CCD1: Construction Code Determination Form

We respectfully request confirmation in conjunction with the Department of Environmental Protection's (DEP) approval, and the plan examiner requests a determination, of the use of a single site connection for 27-27 44th Drive and 44-26 Purves Street.

DEPARTMENT OF ENVIRONMENTAL PROTECTION BUREAU OF
WATER AND SEWER OPERATIONS
SITE PLAN - SITE CONNECTION PROPOSAL
44-26 PURVES STREET DOB #: 420652190
27-27 44TH DRIVE DOB #: 420652225
SCQ - 289/14

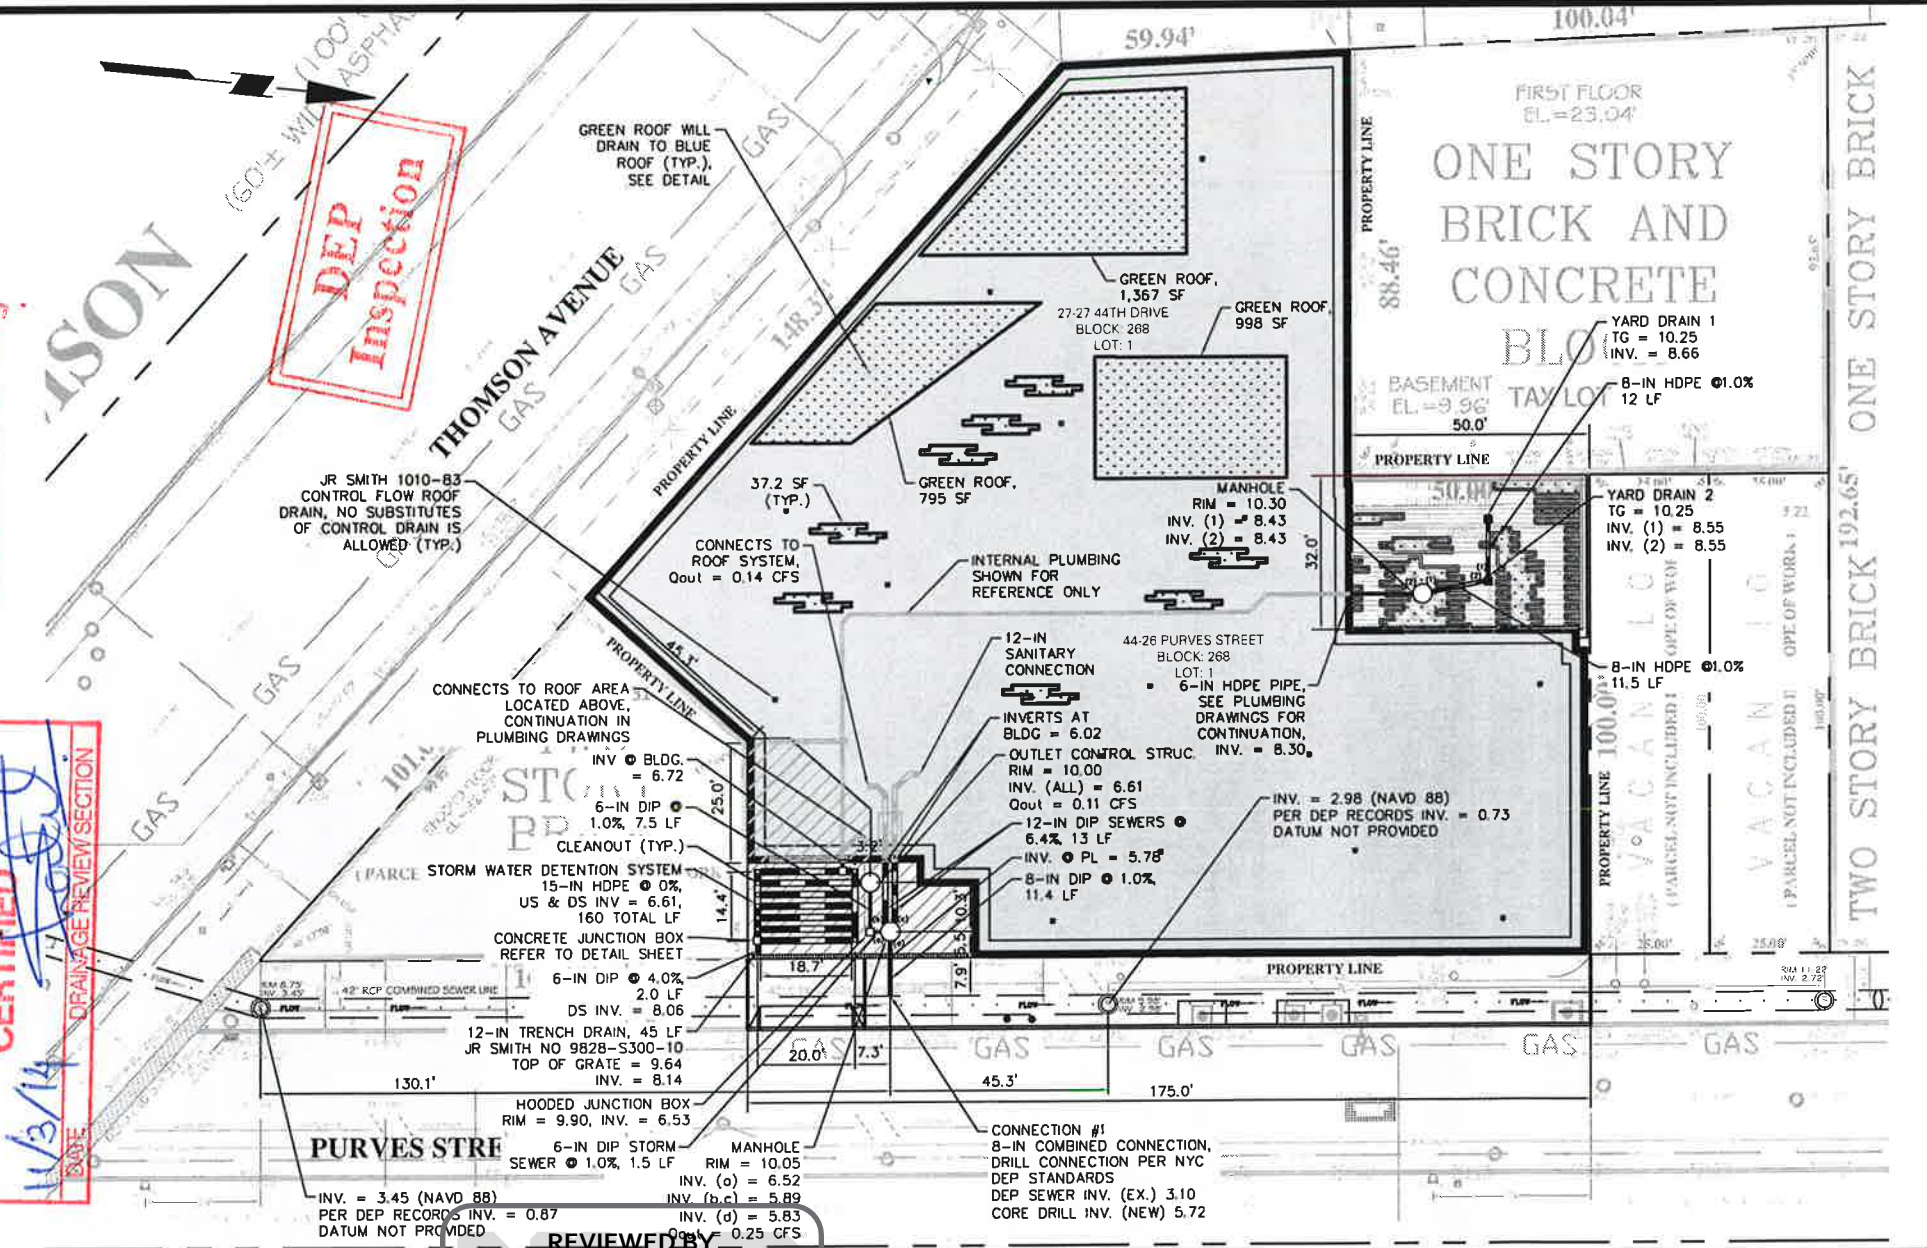
Therefore, based on the above, we respectfully request confirmation of the use of a single site connection for 27-27 44th Drive and 44-26 Purves Street.

The request to accept the proposed single site connection for both 27-27 44 Drive and 44-26 Purves Street is hereby approved with conditions.

Per DEP's acceptance dated 11/3/14 (attached) the proposed single connection is acceptable provide a utility easement is registered with City Record and the CFRN is included on the schedule A/Certificate of Occupancy for both addresses.
